DATE: March 24, 2016

TO: SLDC Hearing Officer

FILE REF.: CASE # V 16-5001 Madrid Mixed Use Variance

Madrid Mixed Use Proposed Development
2889 Hwy 14
Madrid, New Mexico
March 14, 2016

SHEET NUMBER:
SD-2

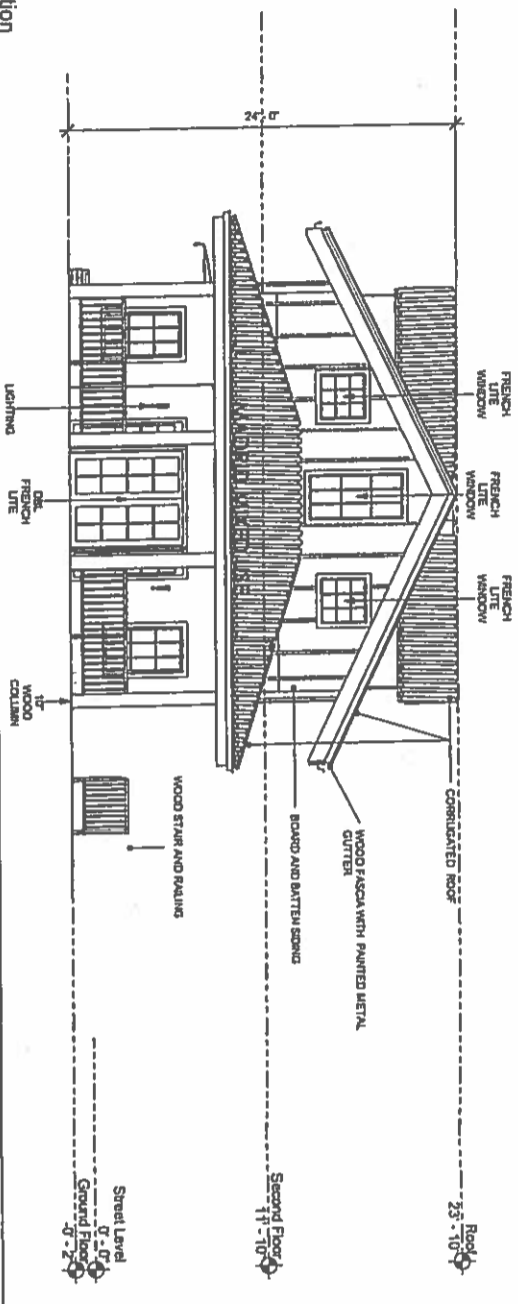
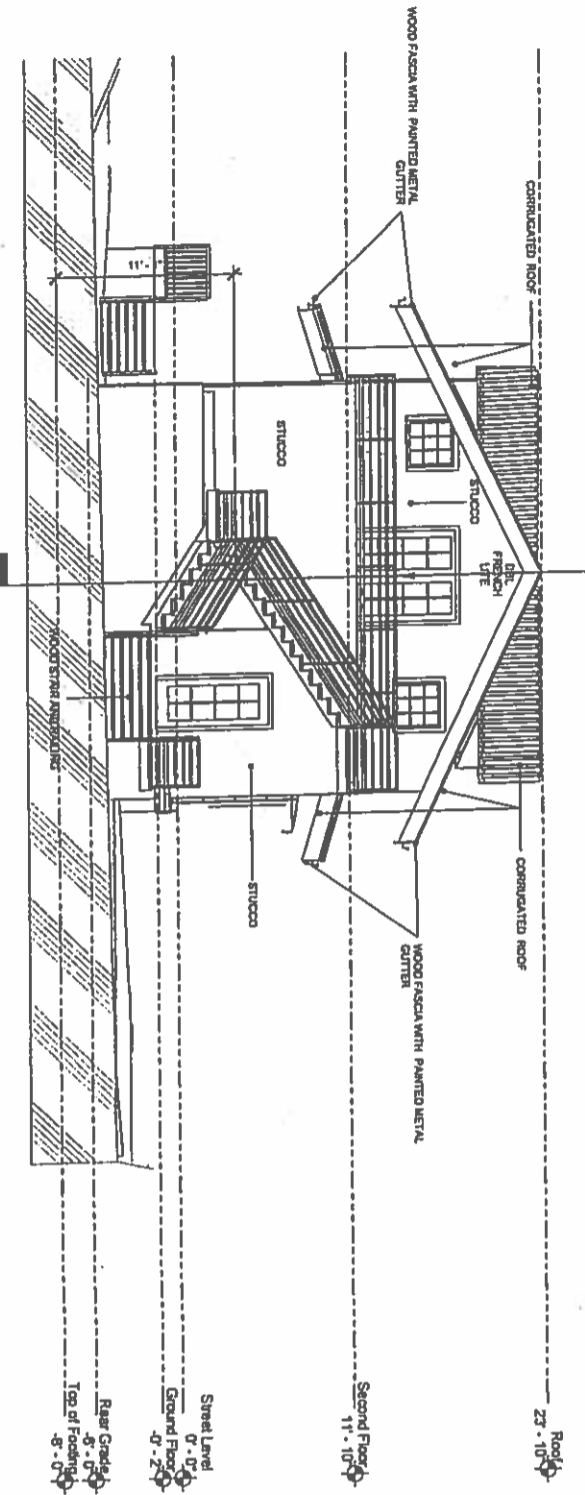
The height at the rear of the proposed structure is designed at 28 feet. Chapter 9, Table 9-6-4, Dimensional Standards MCD Commercial Neighborhood, allows a maximum height of 25 feet. The Applicant is requesting a variance of the Dimensional Standards set forth in Chapter 9, Table 9-6-4, of the SLDC to allow a portion of the proposed structure to exceed 25 feet in height.

The street frontage of the building will conform to the 25 foot height limit. Due to the slope of the site, I would like to obtain approval for the rear (west elevation) to be a total of 28 feet in height. This additional height will not be noticeable from the street and will enhance the look of the buildings as well as make for a viable mixed use project.

Staff recommends denial of the Applicants request for a variance to allow the proposed structure to be constructed 28' in height. Chapter 9, Section 9.6, Table 9-6-4, Dimensional Standards Madrid Community District Commercial Neighborhood states, that the maximum height within a CN Zoning District is 25 feet.

PROJECT #: 15-003
 ISSUE DATE: 8 OCT 2015
 PRODUCTION: ED
 CHECKED BY: ED
 SHEET TITLE:
BUILDING SECTIONS
 SCALE: 3/8" = 1'-0"
 SHEET NUMBER: SD-6

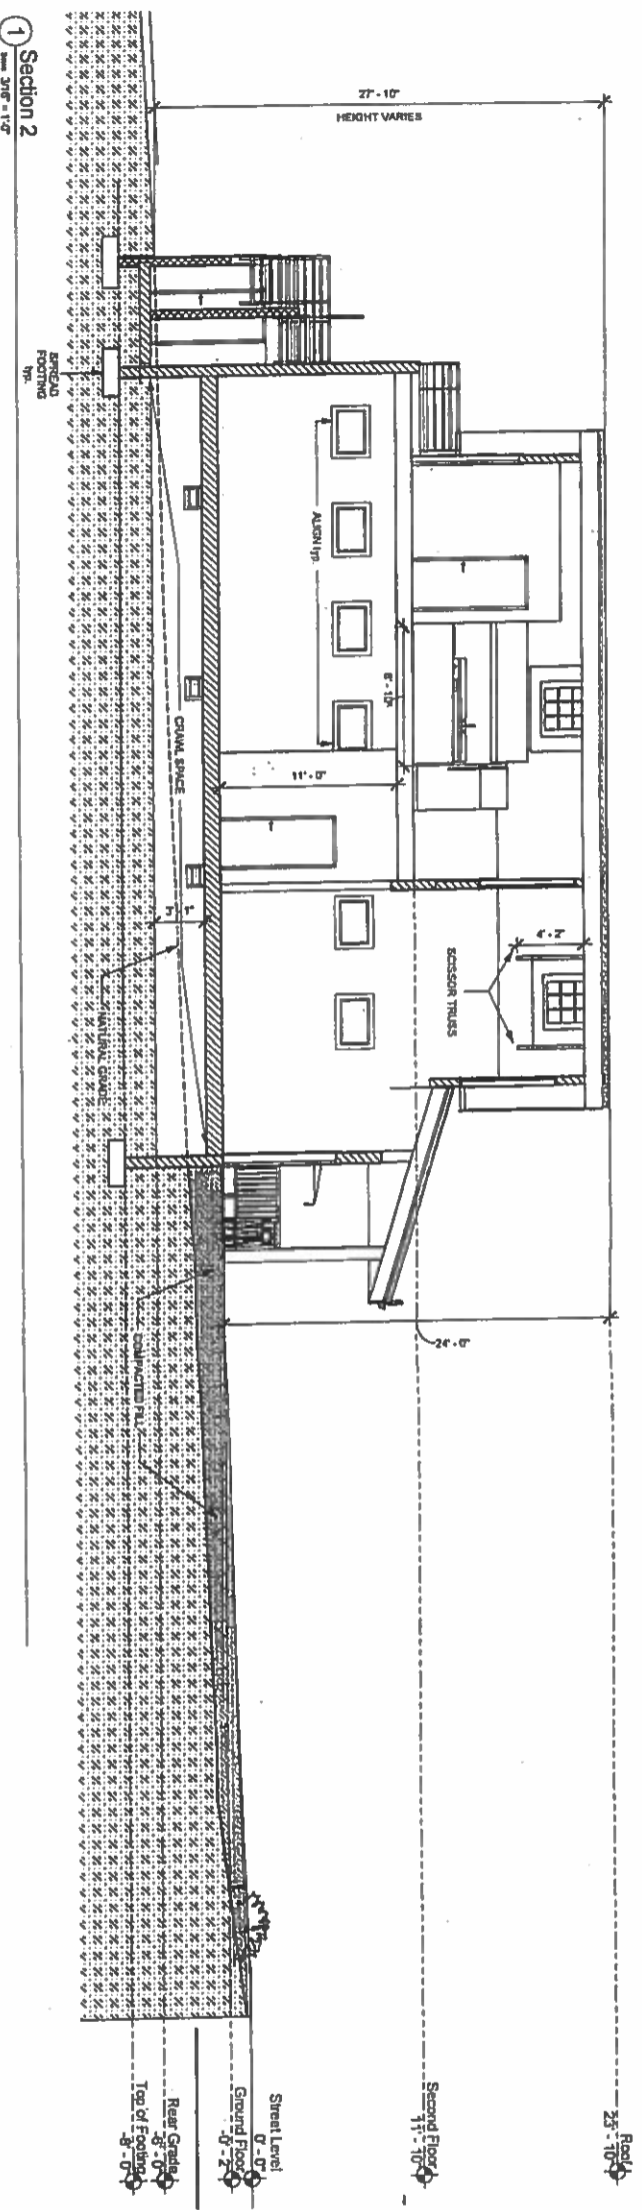
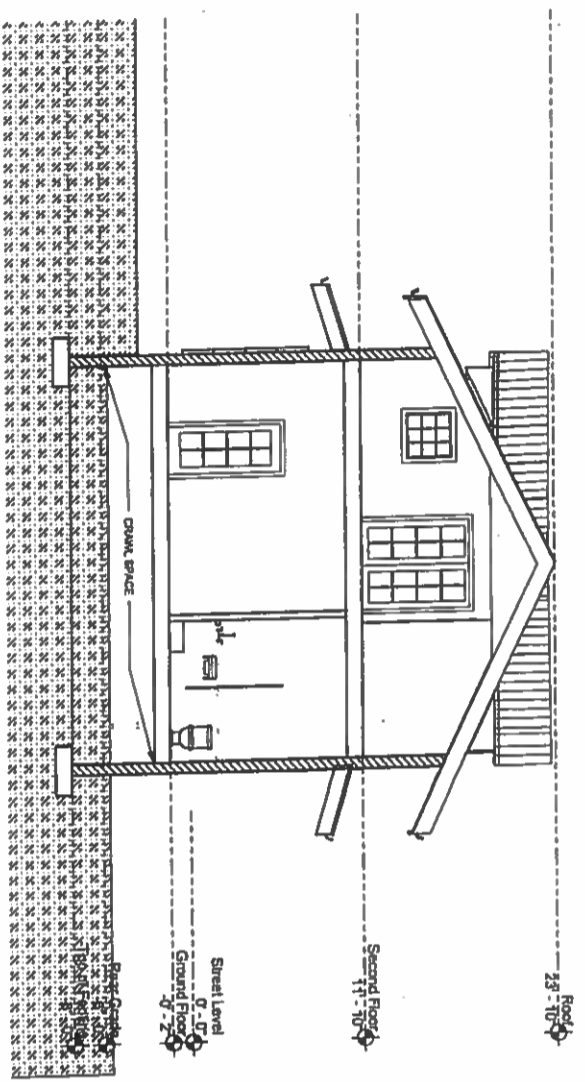
Please note that I am hereby requesting a variance for the height of the building at the rear (west). I have included a cut/fill section thru the property to show the building as it relates to the existing Hwy 14 grade and the existing natural site grades.
